Change of shaftseal on BUUS Iceflakers.

From type 129572

to 011299

Before and after the repair

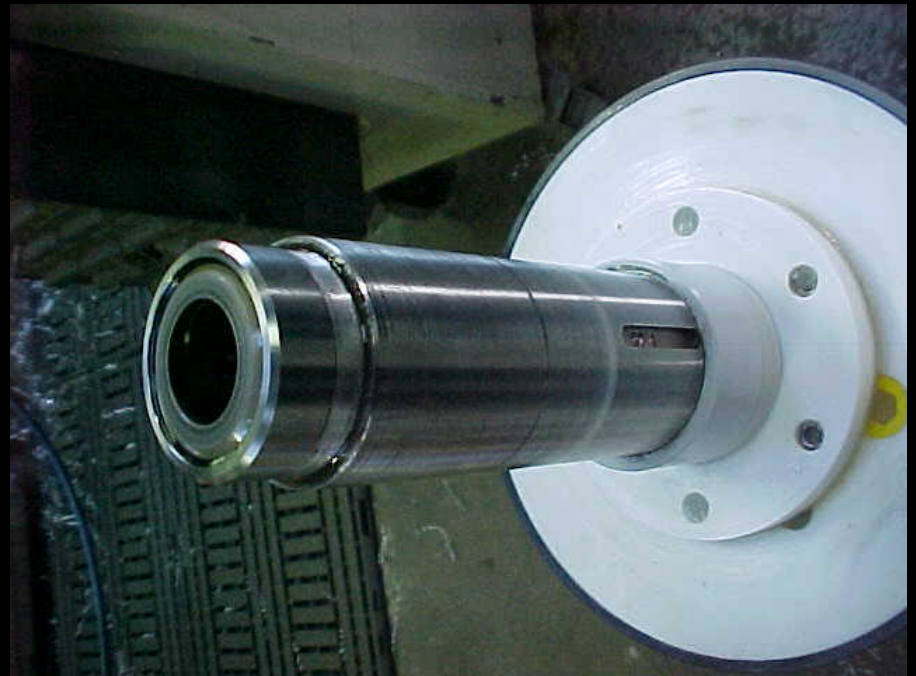
Old type shaft seal

After the repair

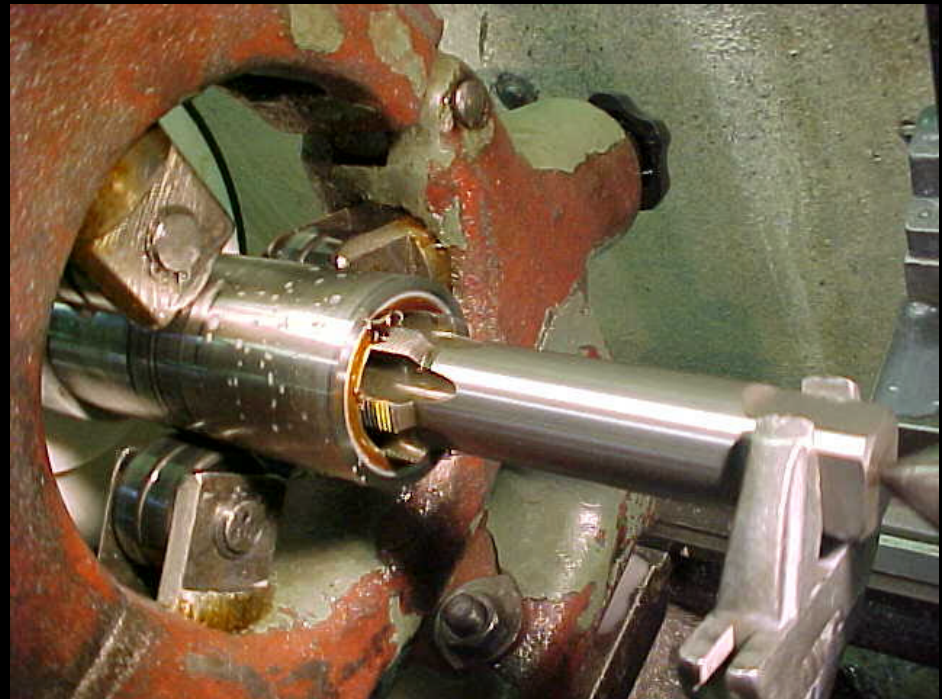
The outer parts of the shafts are removed

A thread for the adapter
is made

The adapter

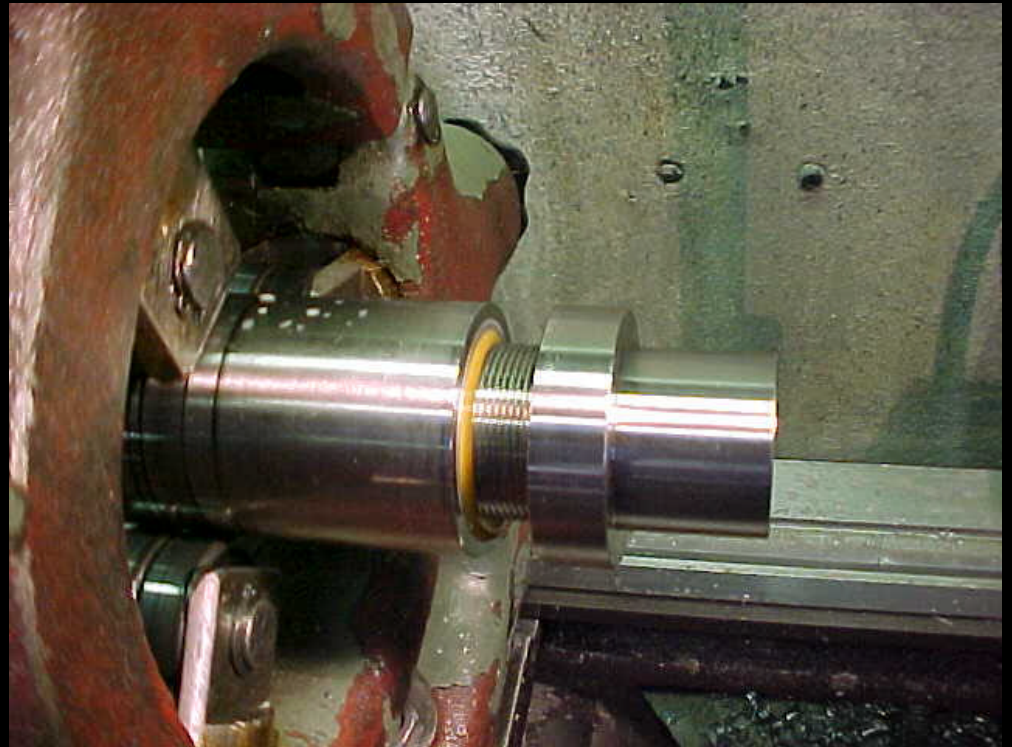
The adapter is mounted

The adapter is mounted
and the drum ready to
be reinstalled
